**PLANNING / DESIGN ASSOCIATES**

Project: 72 Walnut Street / Duplex Development / Minor Site Plan Application # 2006-0230 w/ revisions

PROJECT:  
Minor Site Plan Application  
Shopov Residence, 72 Walnut St.

AMENDED SITE PLAN APPLICATION

## SITE EASEMENT PLAN 1"=10' SHOPOV RESIDENCE DUPLIX RESIDENCE

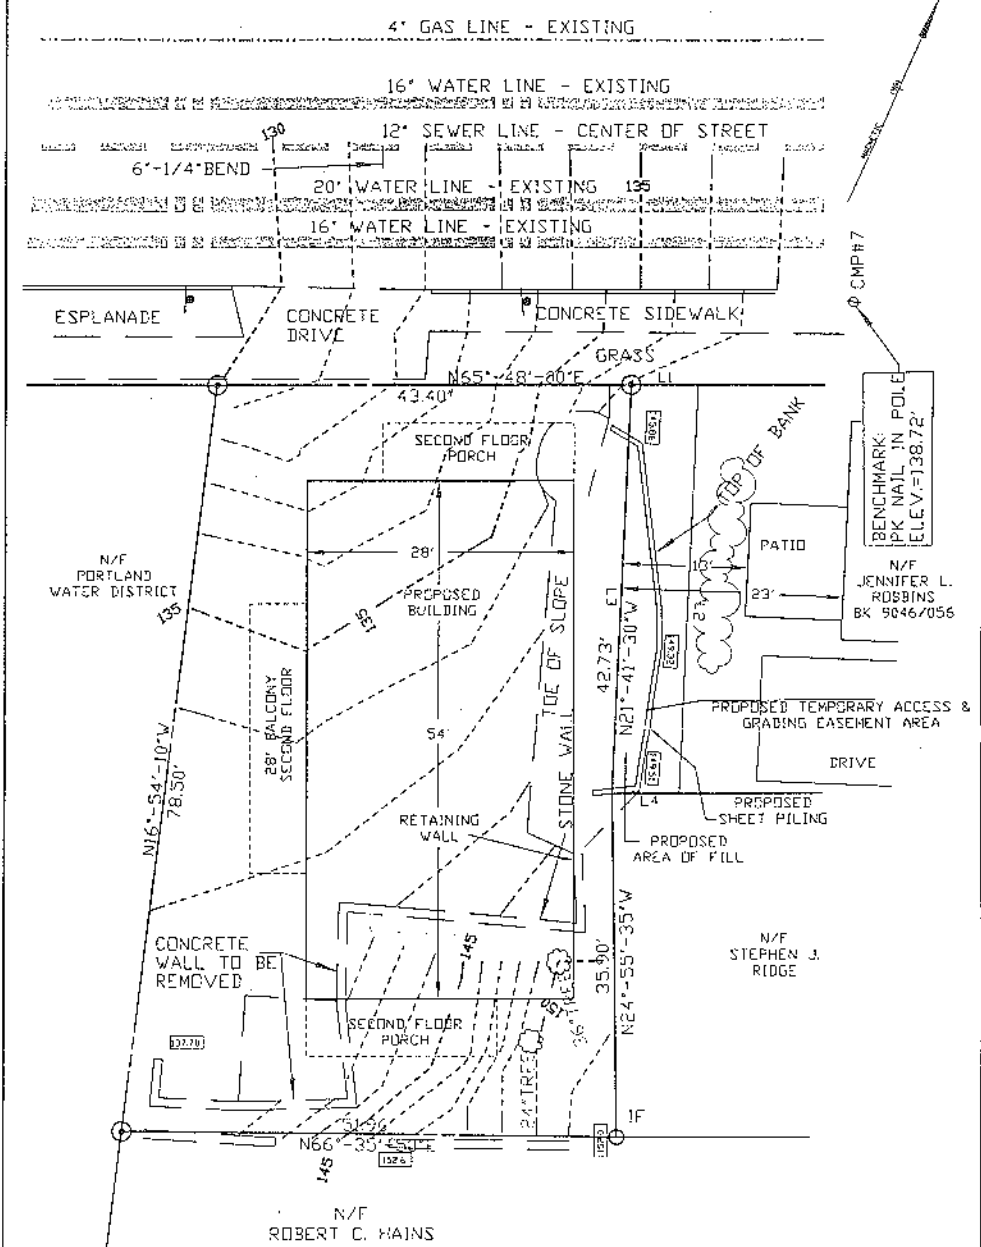
As discussed at the meeting, the applicant feels strongly that grading easements should be granted by the n/f Robbins/ Ridge lots in order to properly re-build this non-structural stone rubble wall that abuts the property. This wall was created in order to provide rear yards, which only benefits Robbins/Ridge. This in turn will be problematic for the abutters' property as well. It is our professional opinion that, even after construction, this wall will continue to encroach into the Shopov lot due to frost action unless it is stabilized as part of the Shopov project. Enclosed is a copy of the proposed easement that the abuttor's declined to sign.

SITE PLAN  
1" = 10'

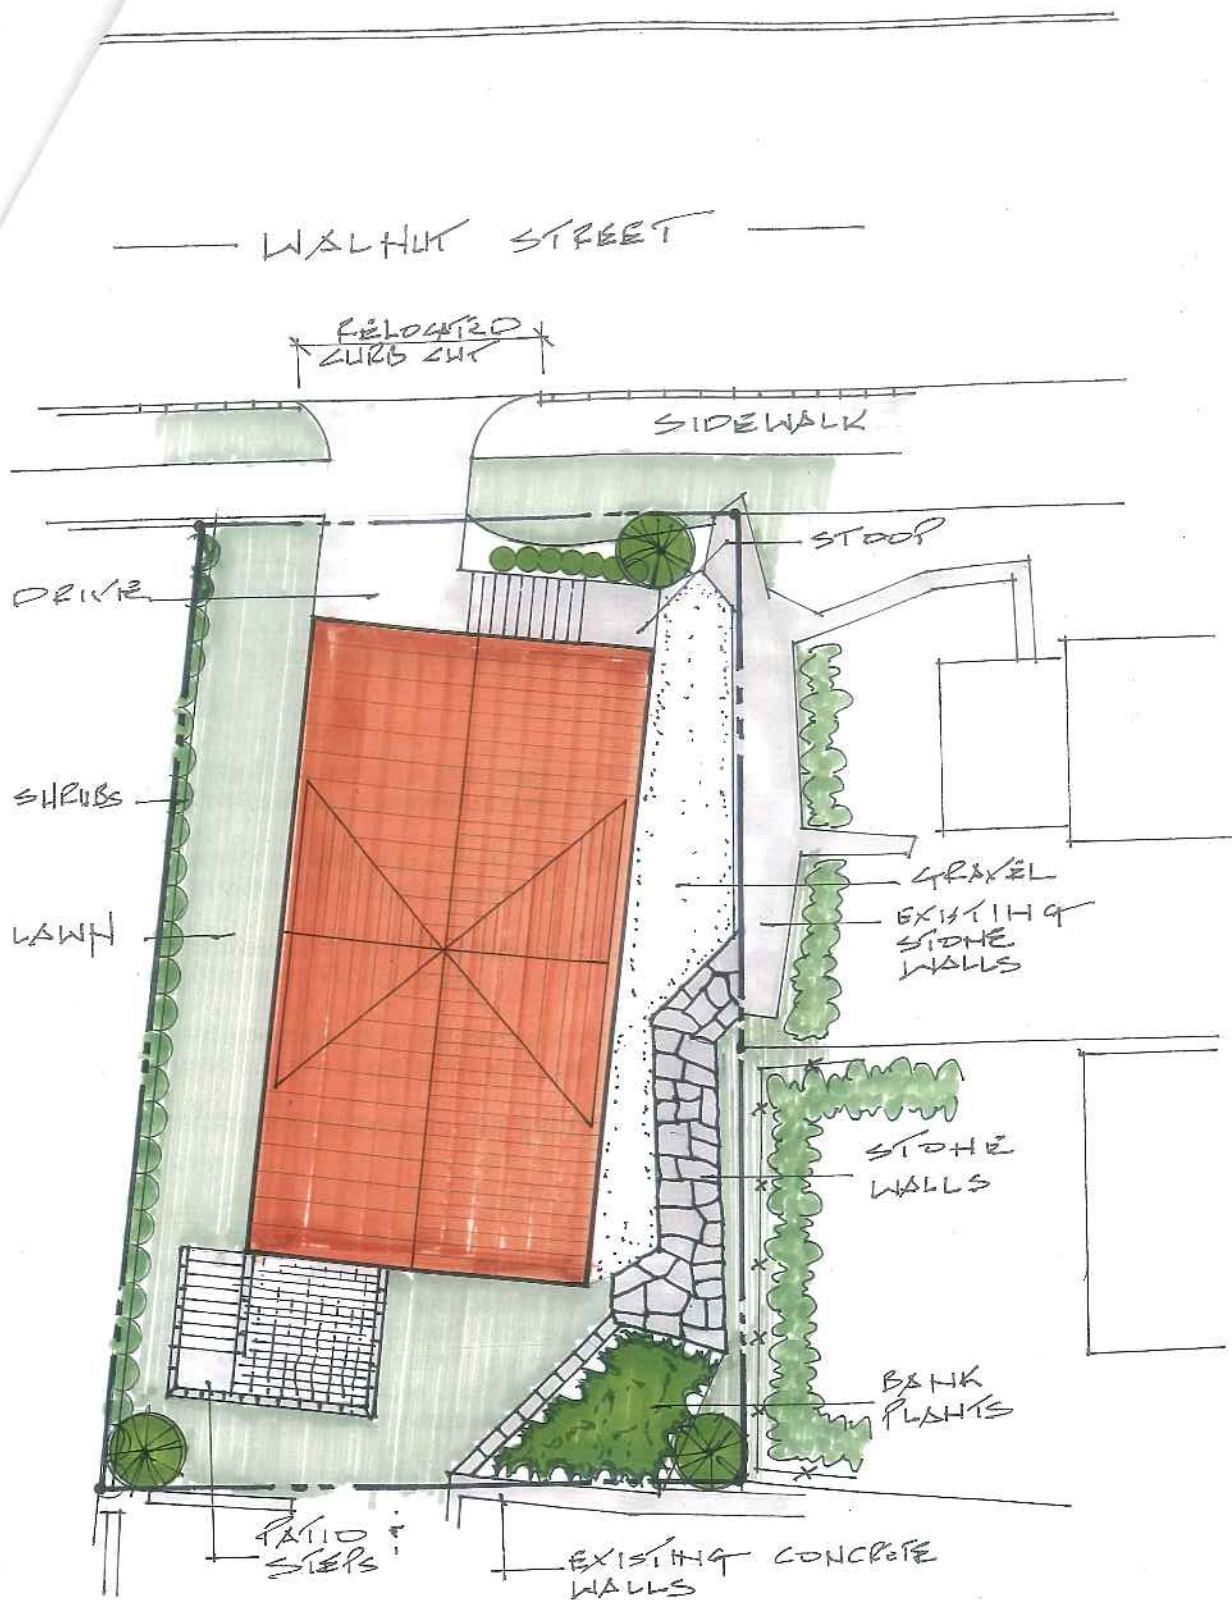
1. The foundation has been redesigned to eliminate the need for the structural block retaining wall along the Ridge property. The foundation footings will step up to eliminate any under-excavation along the existing boulder wall (labeled A) and the proposed stone wall (labeled B). As you recall, Lawson and Ridge have refused to grant temporary grading easements to Shopov in order to rebuild the existing boulder wall. The plan calls for a 25' section of pile shoring in order to stabilize the abutment property during foundation excavation. There is no intrusion onto any abutting property required for implementation of this plan. see site plans and building cross sections

2. The curb cut was moved up Walnut Street 5' in order to align with the driveway and splayed on the uphill side.
3. The storm water plan originally recommended collection of the runoff increase to a rain detention pond. However, due to possible subsurface infiltration onto Mr. Mancini's property, Public Services felt that the only solution was to swale and delay the storm water around the building and across the sidewalk.

SITE PLAN 1" = 10'

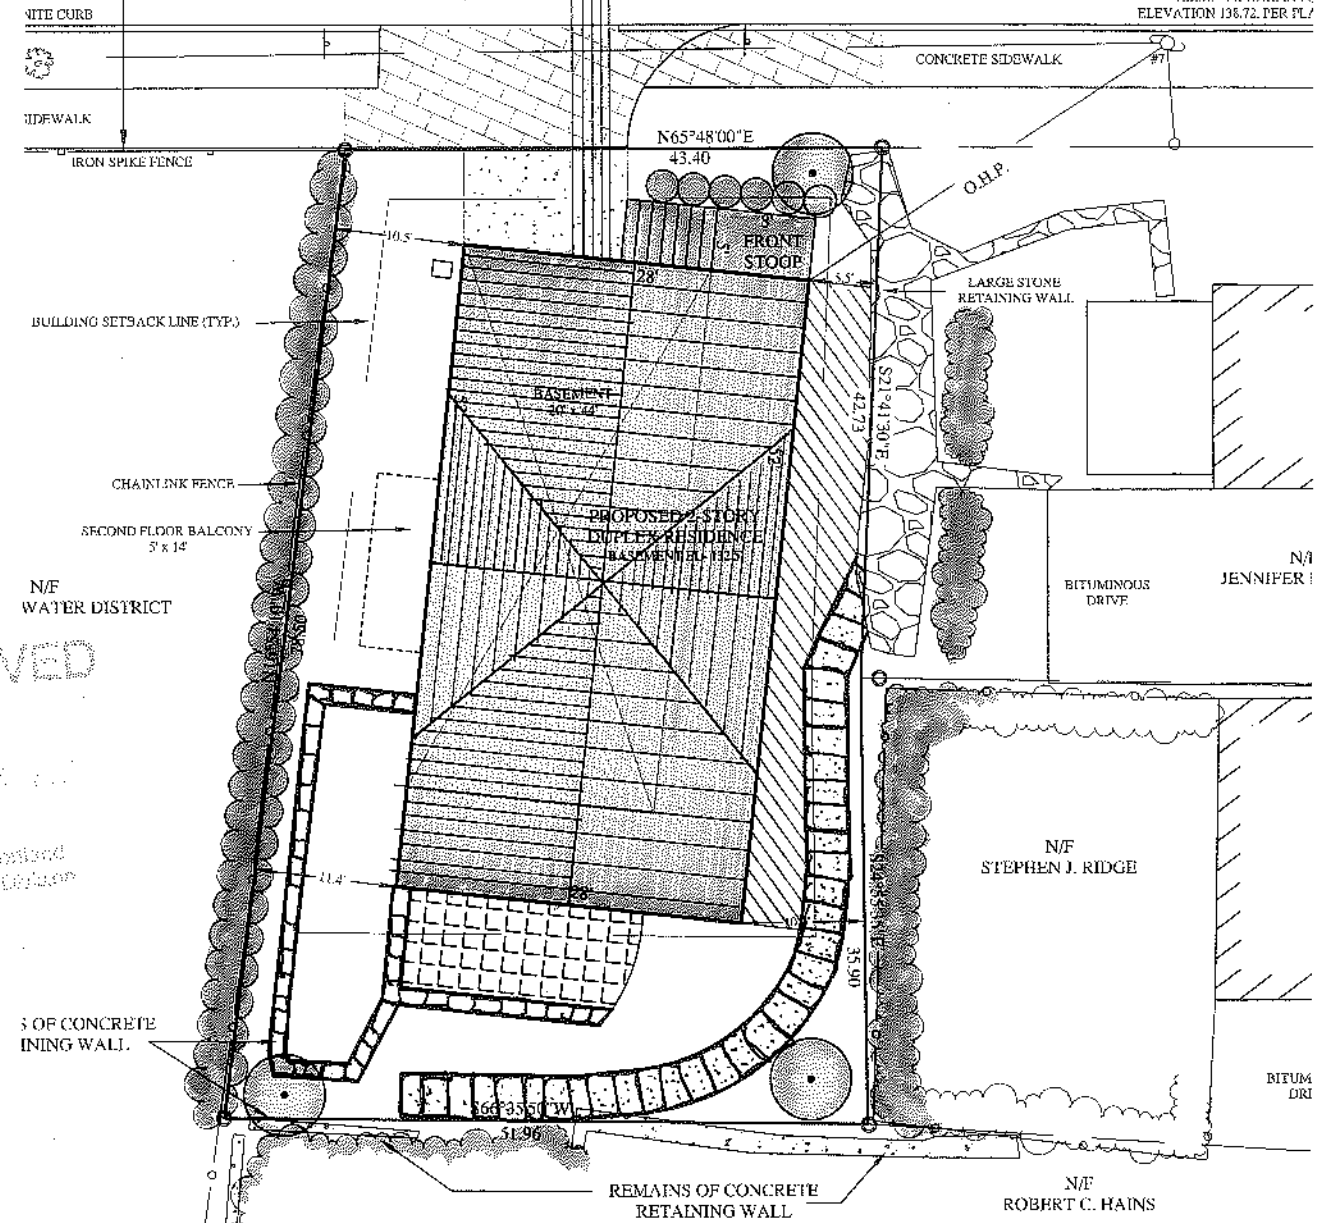
4. The driveway has been widened to 12' and splayed to the uphill side.
5. Details for the site components are provided.
6. Plans for the utility connections ( water / sanitary / gas mains) and overhead electrical are provided.
7. The sidewalk is proposed to be changed from concrete to brick, however we request a waiver to this requirement due to the existing established character of the neighborhood, which is all concrete.
8. An existing conditions survey was prepared which indicates neighborhood features and building heights.
